**DOCUMENT 00 90 00
ADDENDUM**

ADDENDUM NO. [3] Date: February 26, 2021

**RE: WESTERN TECHNICAL COLLEGE
 SPARTA PUBLIC SAFETY EXPANSION
 11177 COUNTY HWY A
 SPARTA, WISCONSIN 54656
 HSR PROJECT NO. 20028**

WESTERN TECHNICAL COLLEGE
SPARTA PUBLIC SAFETY EXPANSION
11177 COUNTY ROAD A
SPARTA, WI 54666
FIRST FLOOR POWER PLAN - AREA B

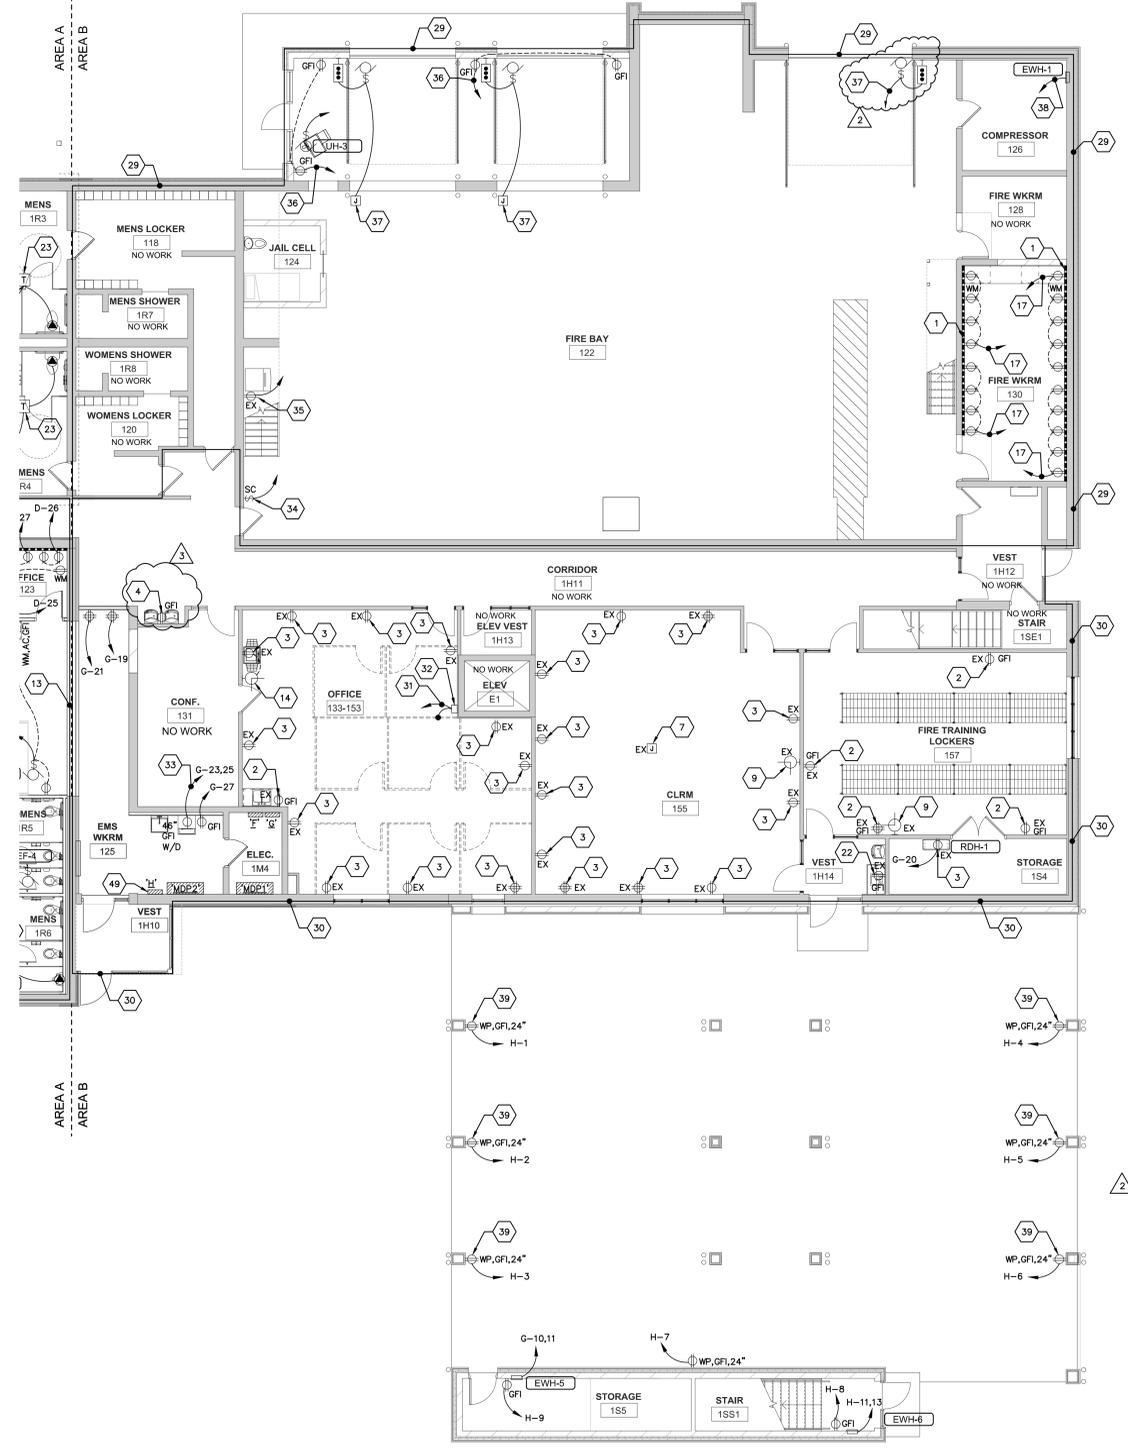
20. Sheet E202 – FIRST FLOOR POWER PLAN – AREA B 30 x 42 attached hereto
 - a. Revisions clouded on Drawing
 - b. In Corridor 1H11; provide a GFI receptacle for electric water cooler, reuse existing branch circuit wiring. Refer to clouded change with Addendum #3 triangle symbol.

1 SECOND FLOOR POWER PLAN - AREA B
E203 SCALE: 1/8" = 1'-0" 20-07-E-PP02

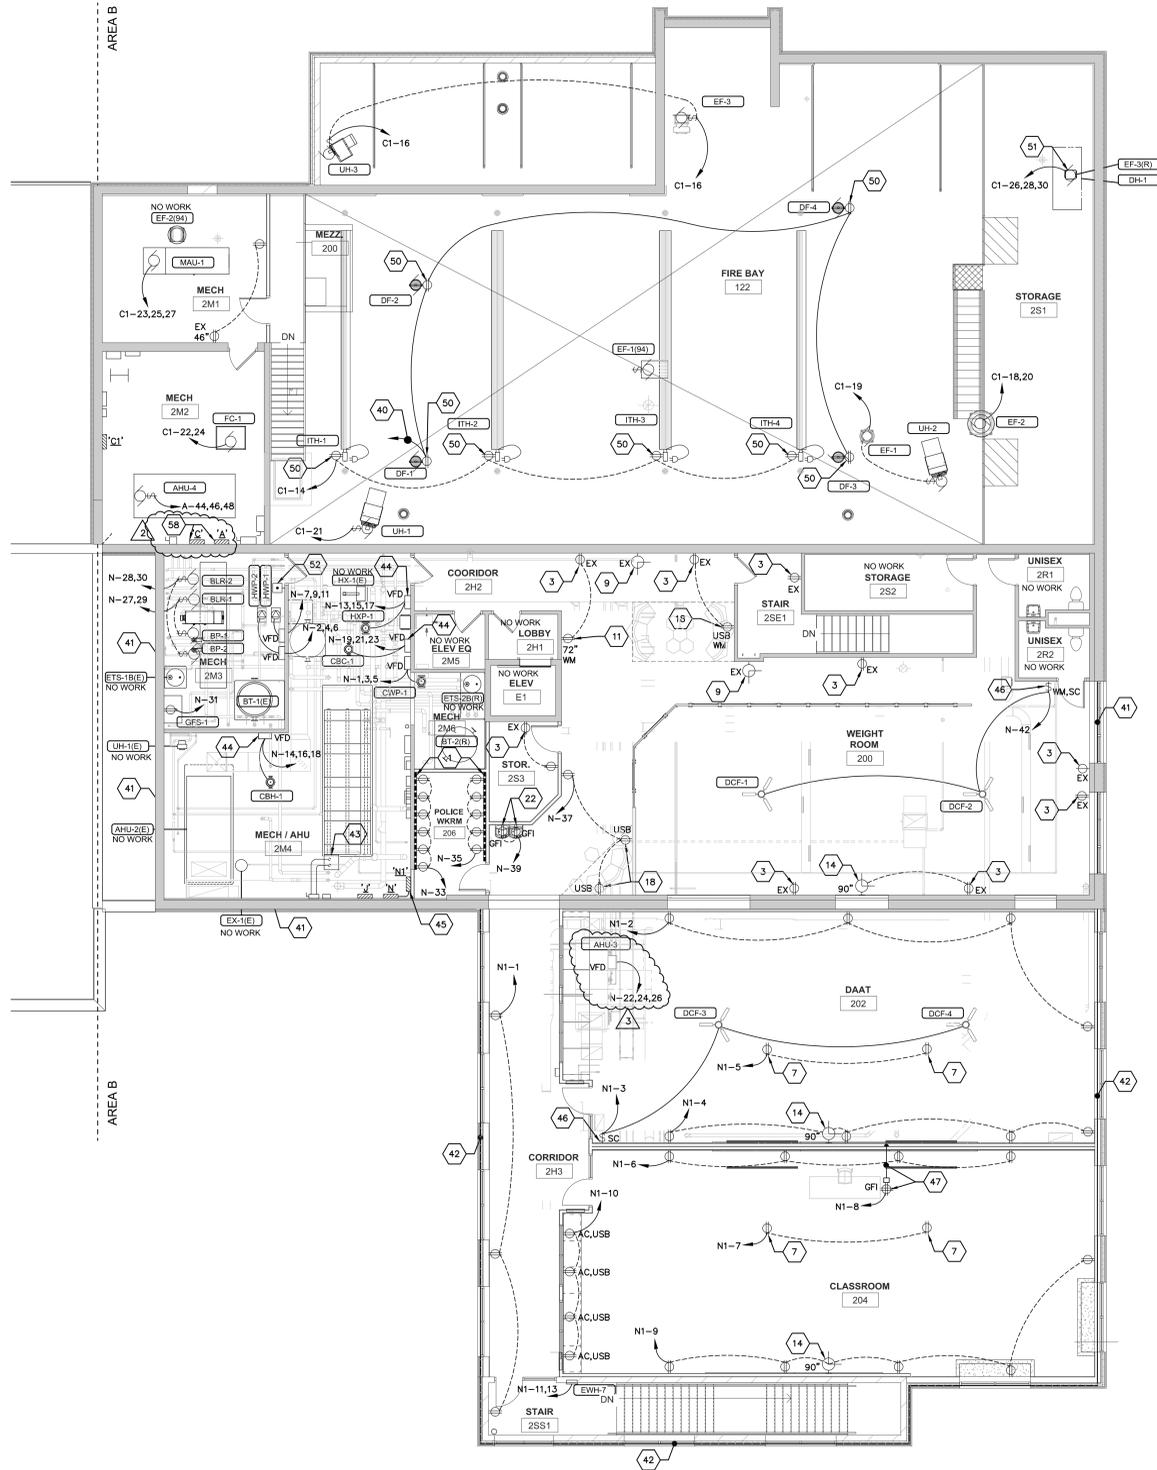
21. Sheet E203 – SECOND FLOOR POWER PLAN – AREA B 30 x 42 attached hereto
 - a. Revisions clouded on Drawing
 - b. Refer to DAAT #202; Air Handling Unit AHU-3 relocated from Weigh Room #200 to this room. Refer to clouded change with Addendum #3 triangle symbol.

1 FIRST FLOOR FIRE ALARM PLAN - AREA A
FA01 SCALE: 1/8" = 1'-0" 26-07-E-FA01

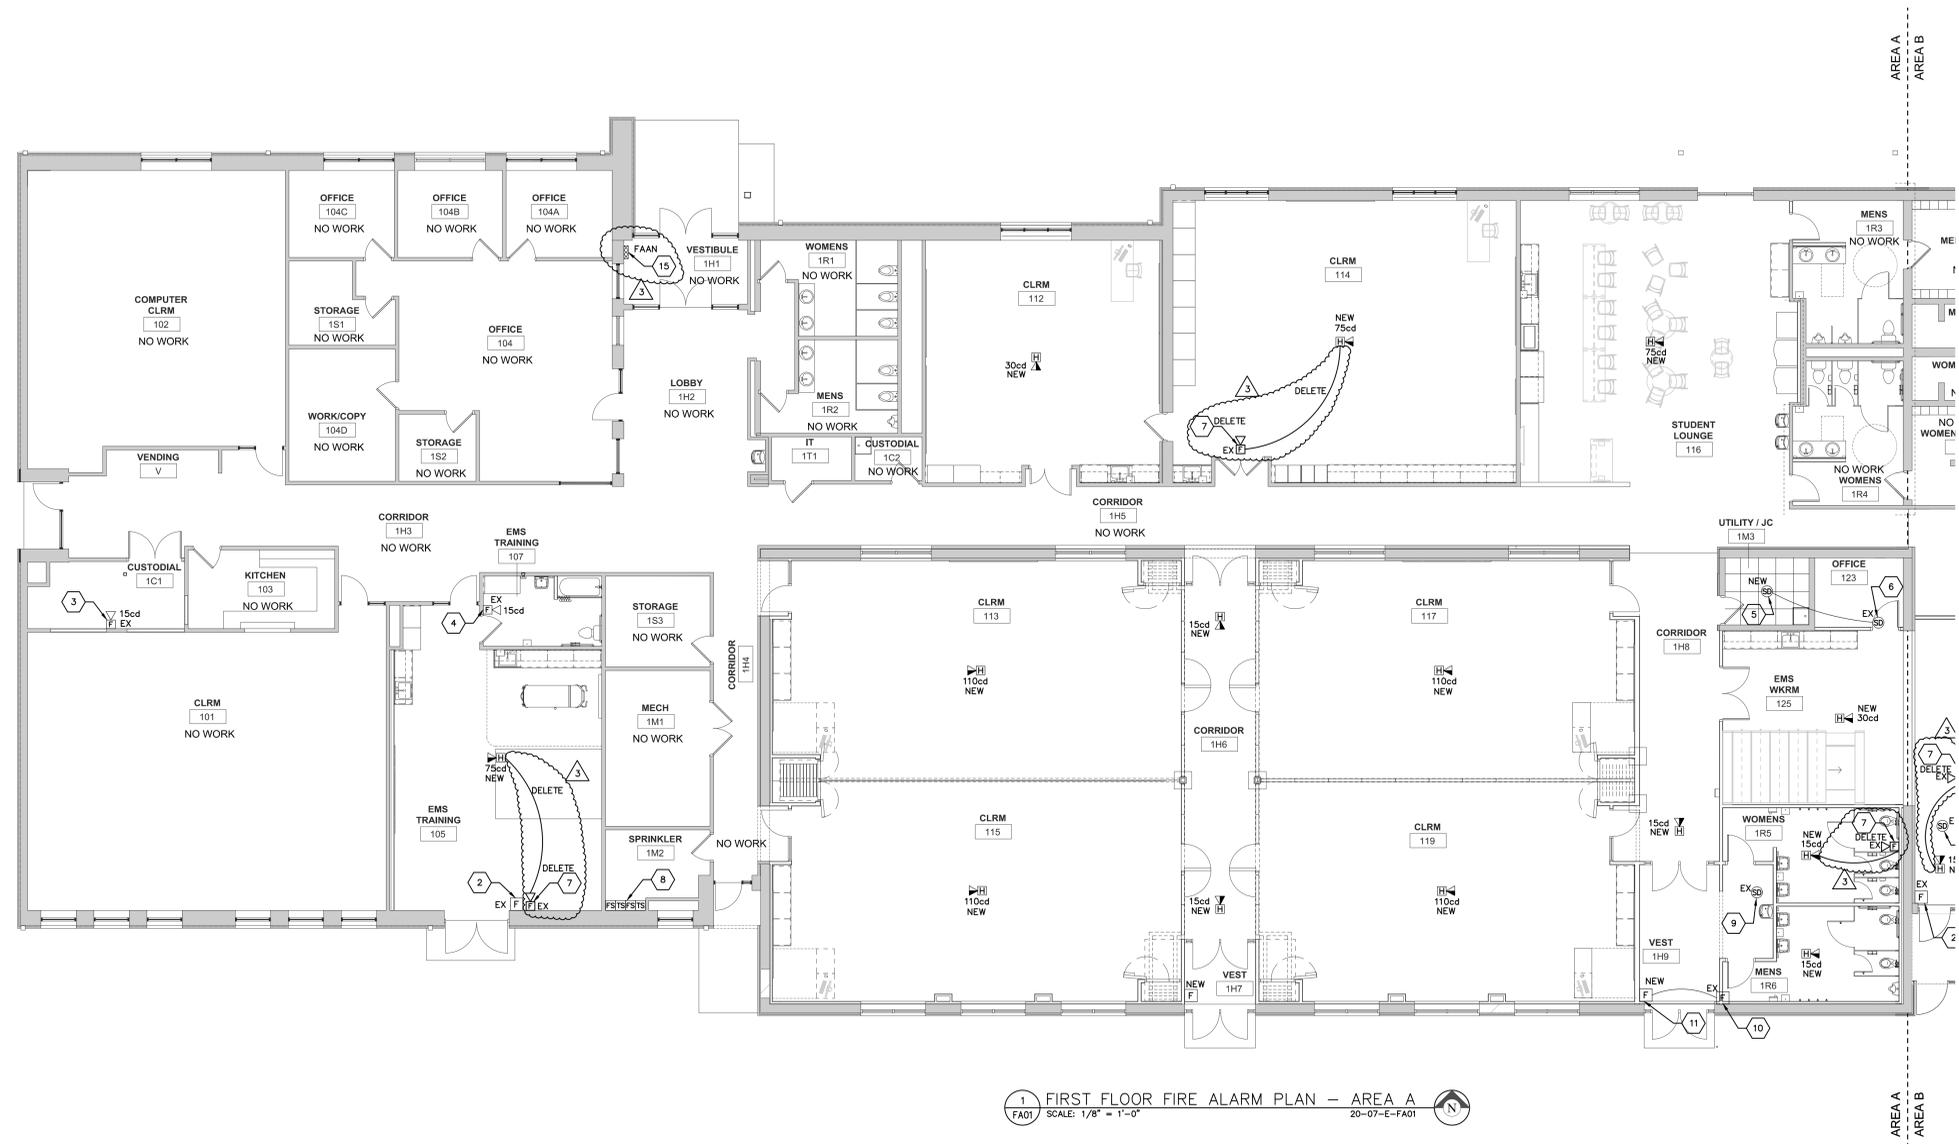
- c. Delete Panelboard 'EM' Schedule.
25. Sheet FA01 – FIRST FLOOR FIRE ALARM PLAN – AREA A 30 x 42 attached hereto
- a. Revisions clouded on Drawing
 - b. Refer to EMS Training Room #105, Classroom #114 and Women's Room 1R5; Do not extend existing fire alarm wiring from previously removed fire alarm device to new fire alarm device. All new fire alarm devices shall be connected with new fire alarm wiring to upgraded fire alarm control panel located in Mech/AHU Room #2M4. Refer to clouded changes with Addendum #3 triangle symbol.

- c. Refer to Vestibule #1H1; Existing Fire Alarm Annunciator panel shall be replaced with new Annunciator panel compatible with upgraded Fire Alarm Control Panel. Refer to clouded change with Addendum #3 triangle symbol.

1 FIRST FLOOR FIRE ALARM PLAN - AREA B
FA02 SCALE: 1/8" = 1'-0" 20-07-E-FA01

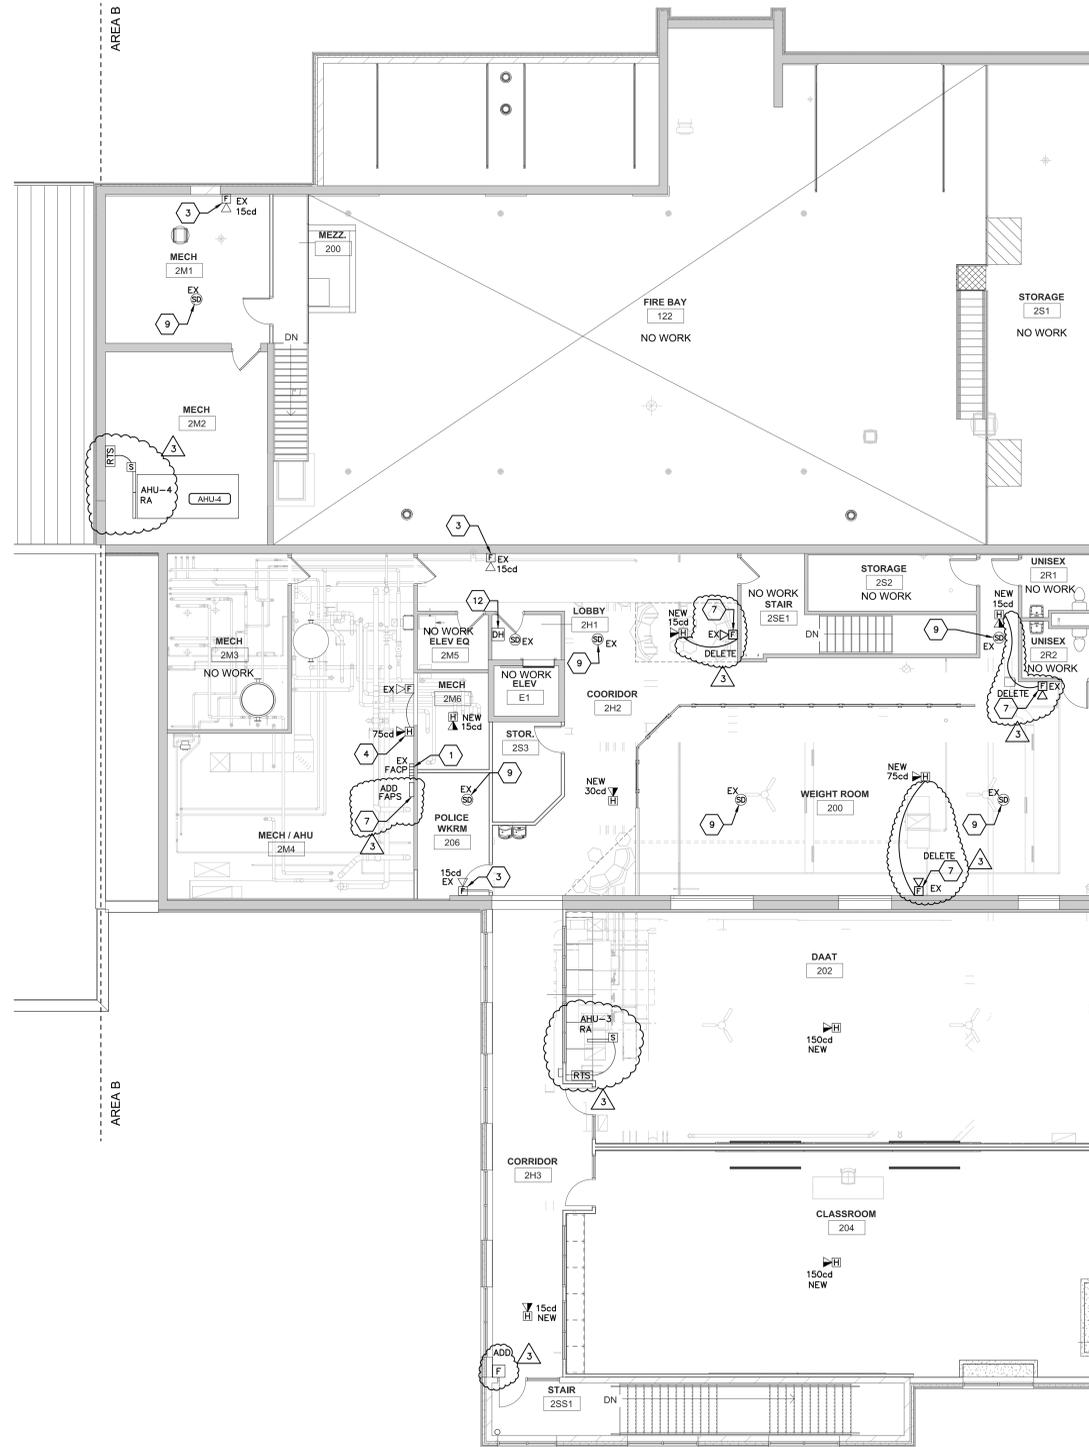
26. Sheet FA02 – FIRST FLOOR FIRE ALARM PLAN – AREA B 30 x 42 attached hereto
- a. Revisions clouded on Drawing
 - b. Refer to EMS Workroom #125, Office #133-153, Classroom #155 and Fire Training Lockers #157; Do not extend existing fire alarm wiring from previously removed fire alarm device to new fire alarm device. All new fire alarm devices shall be connected with new fire alarm wiring to upgraded fire alarm control panel located in Mech/AHU Room #2M4. Refer to clouded changes with Addendum #3 triangle symbol.

- c. In Fire Workroom #130; Delete ceiling mounted notification device, existing wall-mounted notification device to remain as is. Refer to clouded changes with Addendum # triangle symbol.
